COMPLETE MONOGRAPH

2019 GROUP B PUBLIC COMMENT AGENDA

OCTOBER 23 - 30, 2019
RIO HOTEL AND CONVENTION CENTER
LAS VEGAS, NV

2019 Public Comment Agenda

View of roof towards collapsed area

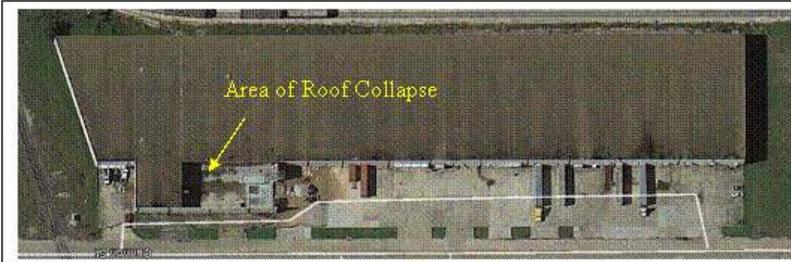
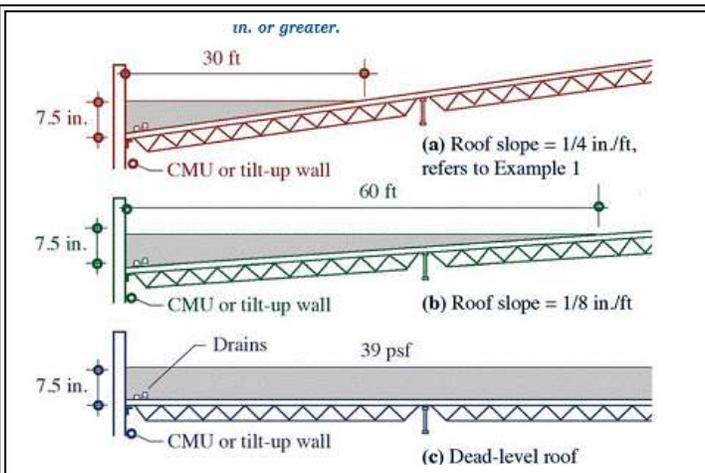
Below is an aerial photograph of a roof collapse in Houston, TX in 2013. The basic failure mode of this roof collapse was ponding instability. The roof slope was 1/8:12. There was a hail event with a large amount (several inches) of small hail that caused water to back up on the roof. There was evidence of ponding water along the edge of the roof. However, the water dried up within two days of a rain with good drying conditions, so the roof met the requirements for "Positive Drainage" as defined in the IBC.

Below left is another photograph showing the same collapse shown above. Below right is a photograph (from a different roof) showing how hail blocks the flow of water on a roof and causes water to back up on the roof.

Figure 1 Hillside light-frame structure. Figure 2. Hillside structure cross-slope and out-of-hill loading.

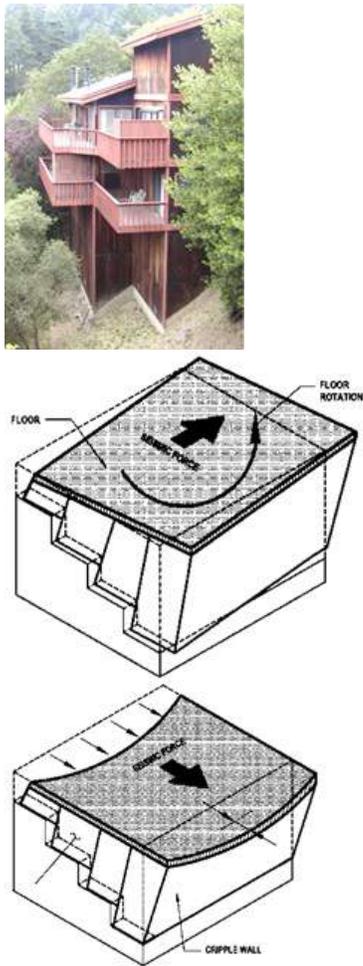
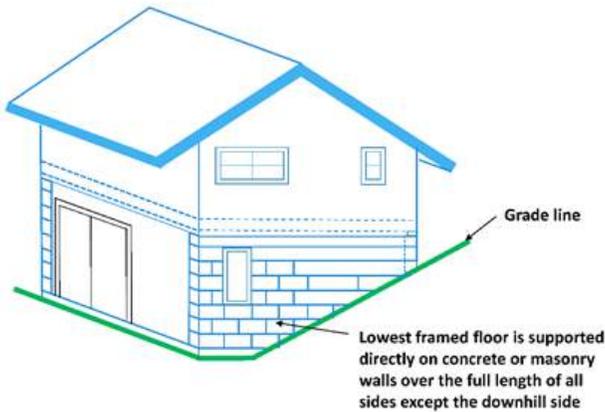
The exception scopes out of irregularity Item 8 dwellings that have full-height concrete or masonry walls (Figure 8) because this configuration was not part of the numerical studies that form the basis of this proposal. For a dwelling with a simple rectangular floor plan, full height concrete or masonry walls would need to occur on three sides to qualify for the exception. For a more complex dwelling plan configuration, additional concrete or masonry walls would be required to qualify for the exception. Dwellings with doors and windows in the concrete or masonry walls still qualify for the exception. In all dwellings the concrete or masonry walls will need to conform to applicable IRC provisions.

FIGURE 1 - IMAGINARY LINES BETWEEN TOWNHOUSES

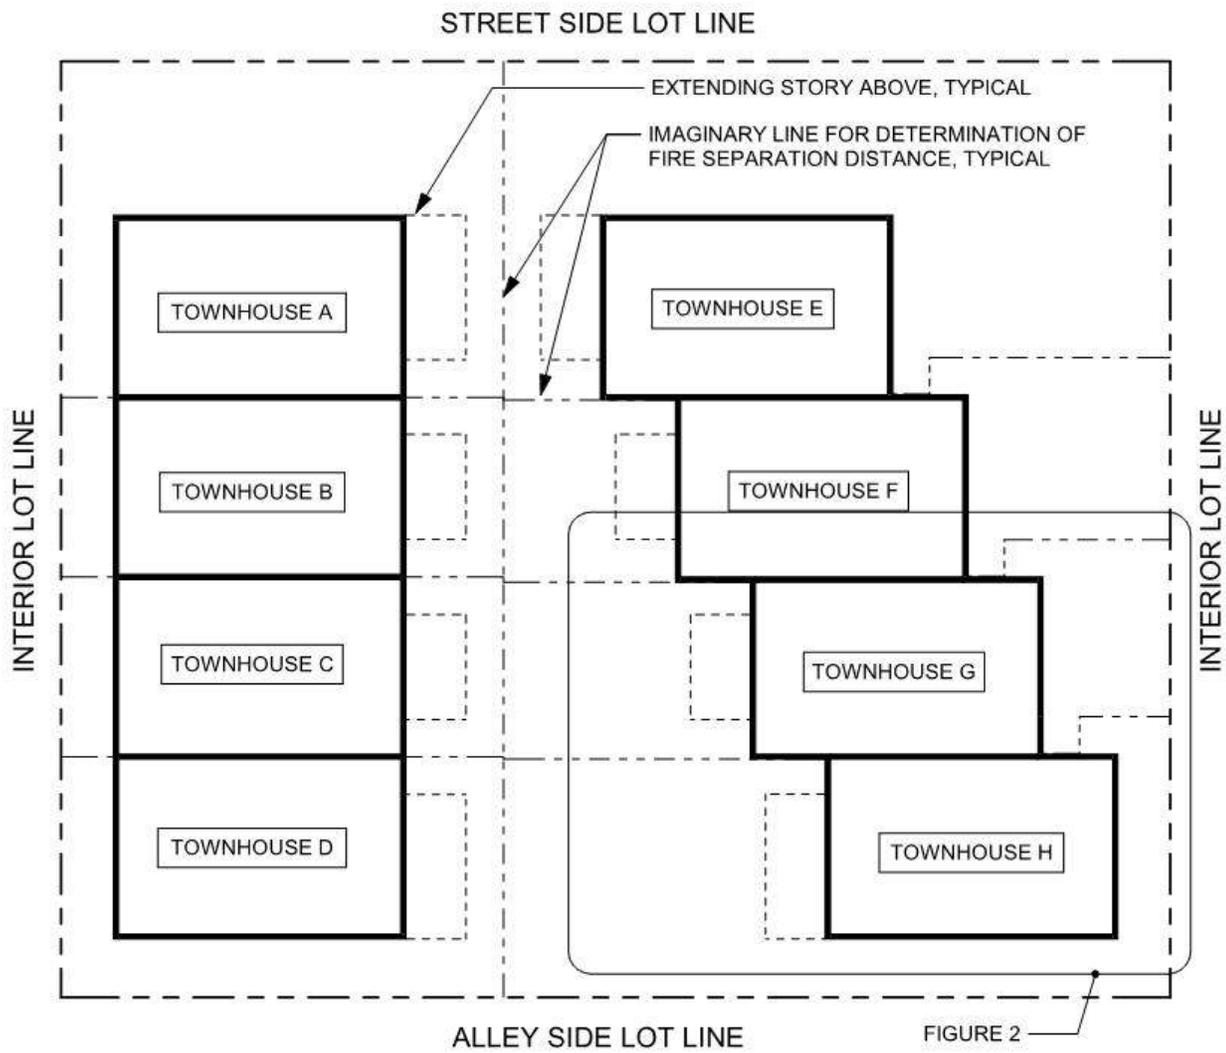
This proposal brings back the 2012 townhouse exterior wall requirements that are assumed to have been inadvertently removed from the code. It does this by adding townhouses to the scoping of R302.1 for exterior walls and by revising the definition of fire separation distance to include imaginary lines between townhouses (rather than calling townhouses separate buildings, which they are not). Townhouse exterior walls that are adjacent to lot lines would meet exterior wall requirements based on fire separation distance to the lot lines. Townhouse exterior walls that are adjacent to other townhouses, would meet exterior wall requirements based on fire separation distance to the imaginary line between two townhouses. See Figures 1 and 2 below for application examples for this proposal. This proposal is necessary to fill the current hole in the code regarding exterior wall requirements for townhouses.

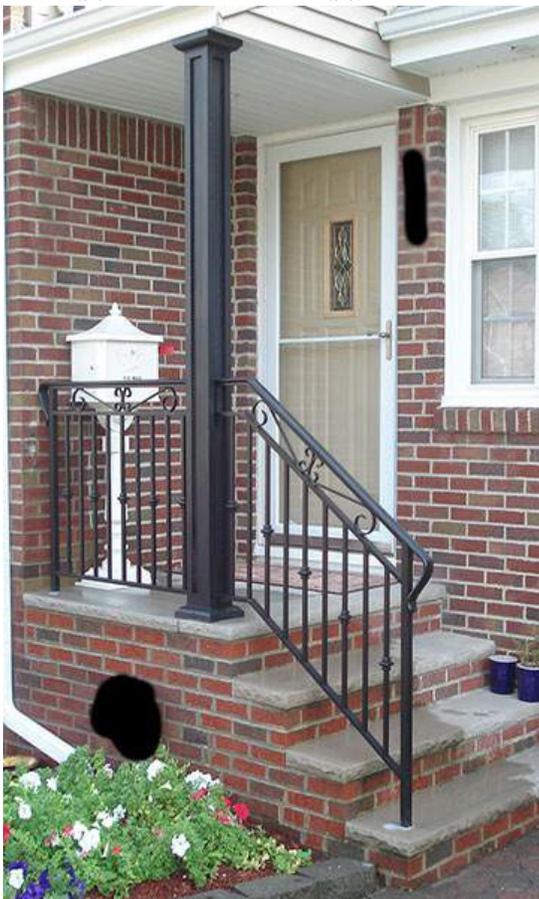
2. The next commonly used ending non ending termination is a vertical continuous loop on each end of again a handrail molding set on posts which is not a part of a guard or guard system. At each end, the handrail returns into a continuous loop establishing the safety terminal on each end. (See Picture RCNOMMA-02.jpg)

Figure. Examples of to-scale marking layouts on a 4-foot by 8-foot insulation board that comply with this proposal.

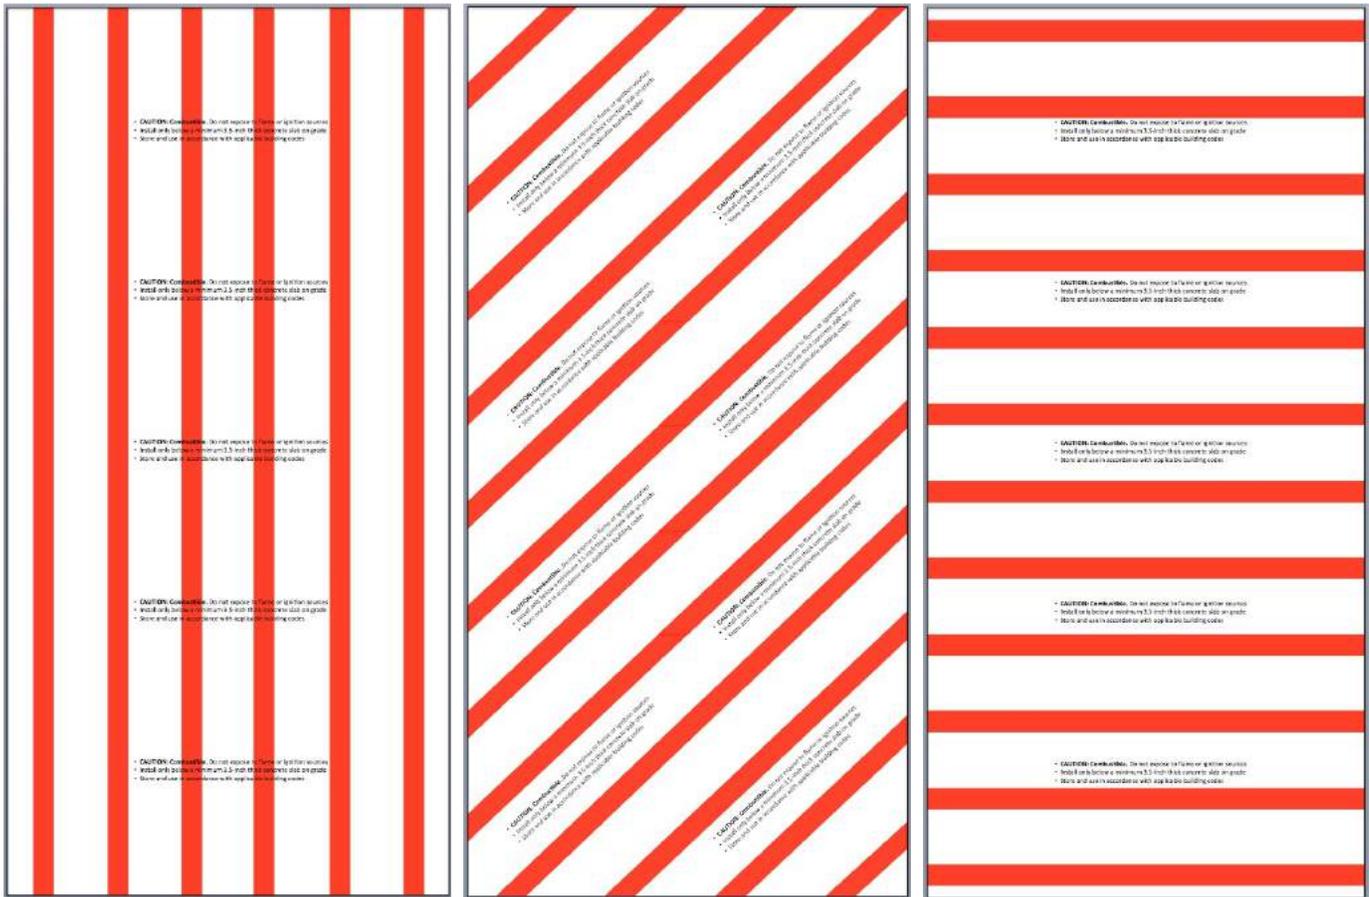
- The International Association of Fire Fighters support this proposal to reduce the unnecessary use of flame retardants which could harm their health.
- When there is no fire safety benefit (as is the case for flame retardants in below-slab insulation) there is no rationale for a requirement leading to the use of flame retardants.
- The language of intent of the IRC states: "The purpose of this code is...to safeguard the public safety, health and general welfare...from...hazards attributed to the built environment." I-codes limit exposure to other toxics based on evidence that materials present health hazards.

Figure 9 FR EPS vs Non-FR EPS Methenamine Pill Test ASTM D2859

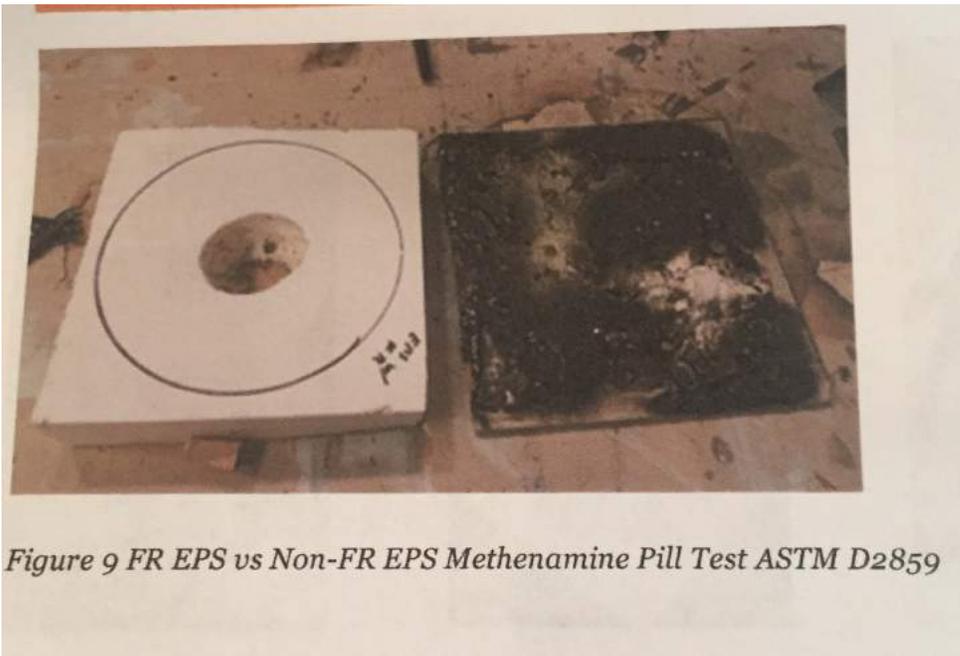
4. The difference in flame spread resulting from applying the methenamine pill to FR EPS foam and Non-FR EPS foam is astounding, as shown in Figure 9 of the OSU report: while very little happened to the FR foam, the non Fr foam burnt completely. The picture below shows the flame spread by the two foams, with the Non-FR one on the left.

Figure 1

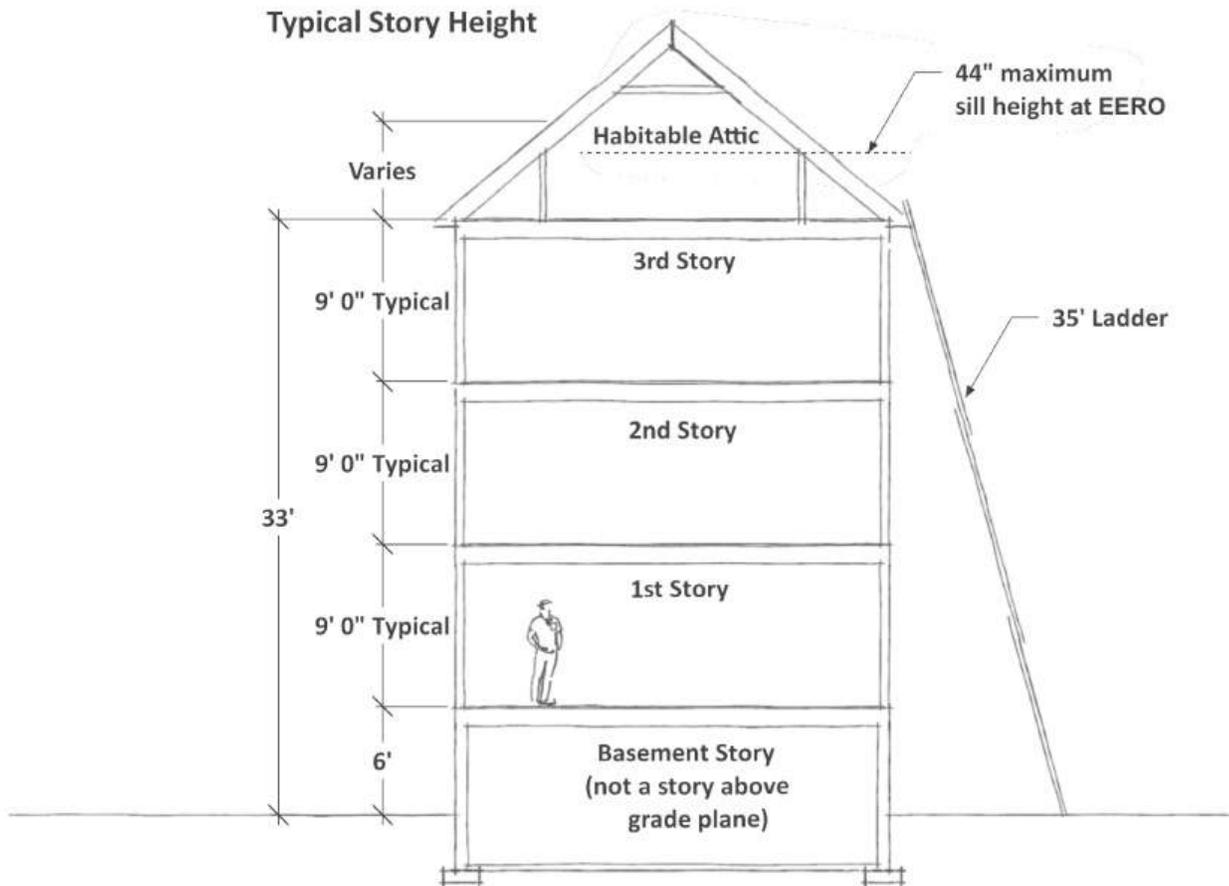
For a three-story, one-family dwelling with habitable space in the attic, the maximum story height is limited to 11'-7" in both the IRC and the IBC. Using both a typical story height (8'-0" ceiling height with a 1'-0" structural space) and the maximum story height, the following figures illustrate some possible building heights that can be achieved. Along with this comparison, Table 1 highlights some life-safety features that would result when these structures are constructed under either the IRC or the IBC. It should also be noted that the code currently does not bring into consideration habitable attics that include dormers or various roof styles (such as a mansard roof) that could easily blur the lines of the current definitions and create spaces that appear to miss the intentions of the original code change proposal.

Figure 3: Walkout basement (not considered a story above grade plane) with typical story height, floor-to-floor, of 9'-0"

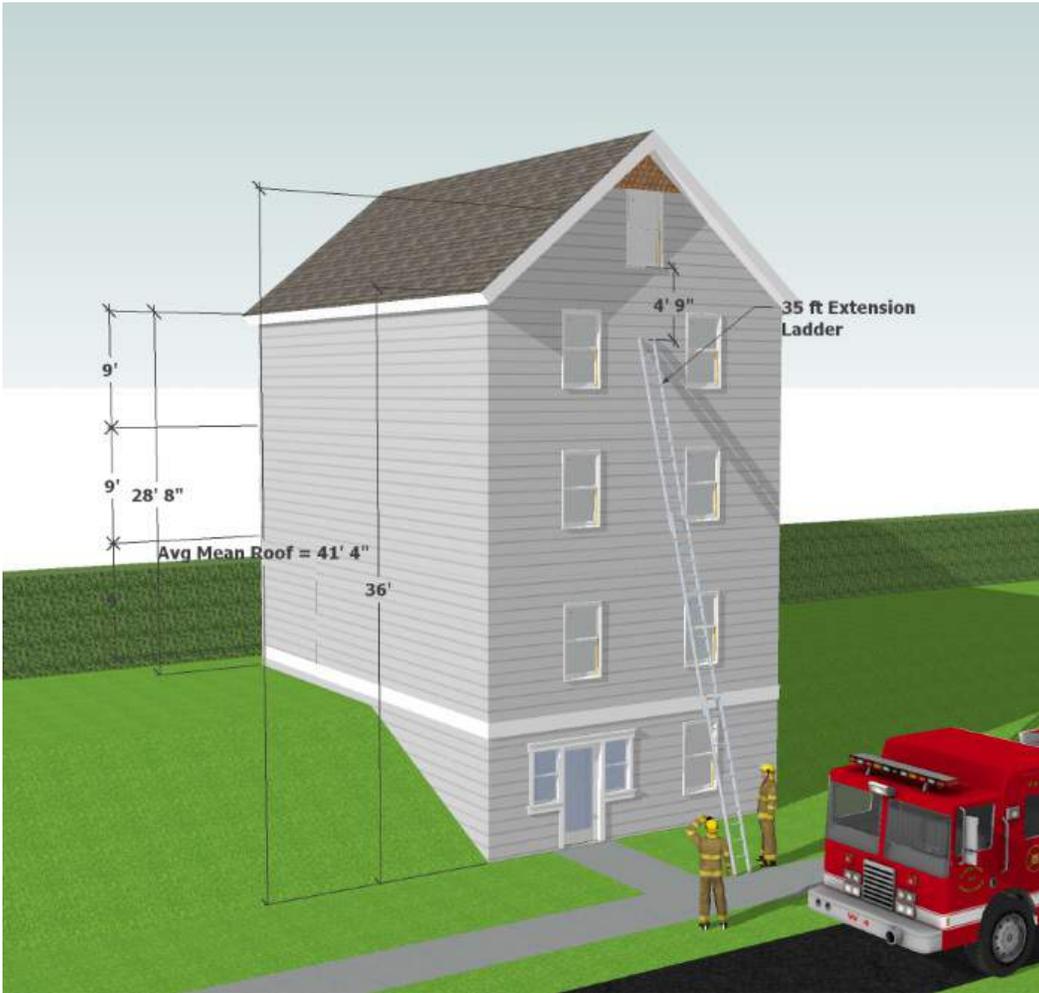
As is shown in Table 1, the result of applying either the IRC or the IBC would result in different safety levels for the same structure.

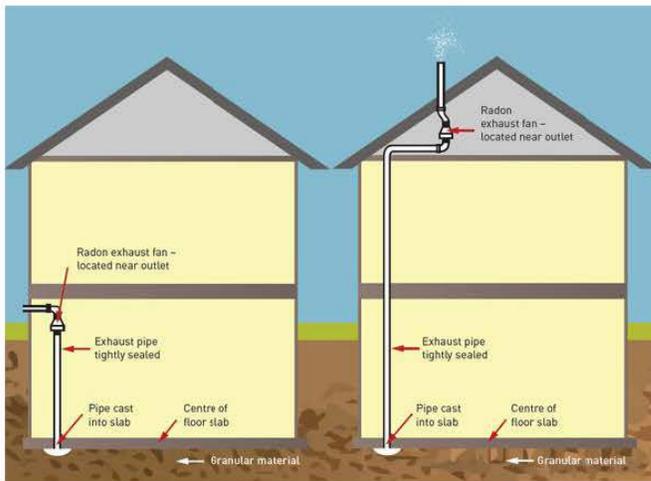
Reason: The intent of this proposal is to allow sidewall venting of radon reduction systems without changing the other provisions of Appendix F. An active system is required if the sidewall venting option is chosen, but builders and owners still have the option of constructing a passive through-the-roof system. The sidewall termination option can provide advantages for those who have already decided to install a radon fan and want the benefits of simple vent routing or want to have better access to the fan for monitoring and maintenance. The side-vent option reduces ice formation on the roof vent. In cold climates ice forms on the roof vent as warm moist air meets cold outdoor air.
